**For: Apparatus and Method for Enabling Use of Low Power Satellites, Such as C-band, to Broadcast to Mobile and Non-Directional Receivers, and Signal Design Therefor**

**PRE-APPEAL BRIEF REQUEST FOR REVIEW**

### The Claimed Invention

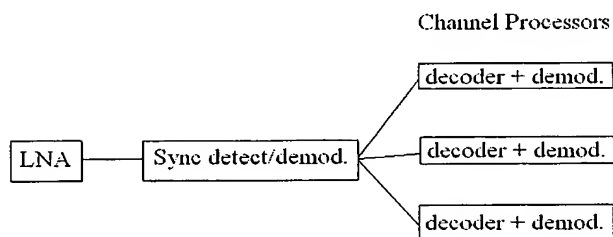
The illustration at right shows what is claimed. The elements positively recited in claim 26 include a plurality of channel processors connected to a sync detection and modulation unit, each of the channel processors also including its own demodulator (as well as spread spectrum and error correction decoders). Hladlik merely discloses that the channel processors includes a demodulator, i.e., the three blocks at the right side of the illustration. **Hladlik does not disclose the block in the middle of the illustration labeled "Sync detect/demod."** and the Examiner does not even attempt to argue that this positively claimed element, which was

*The Hladlik patent only discloses demodulators in the channel processors (see Fig. 2) and not an additional sync detection and demodulation unit (for recovering an additional timing signal added during uplink*

demodulator units 86 correspond to the claimed demodulator included in each of the channel processors and cannot provide the advantages of the additional sync detection and demodulation unit to which the channel processors are connected.
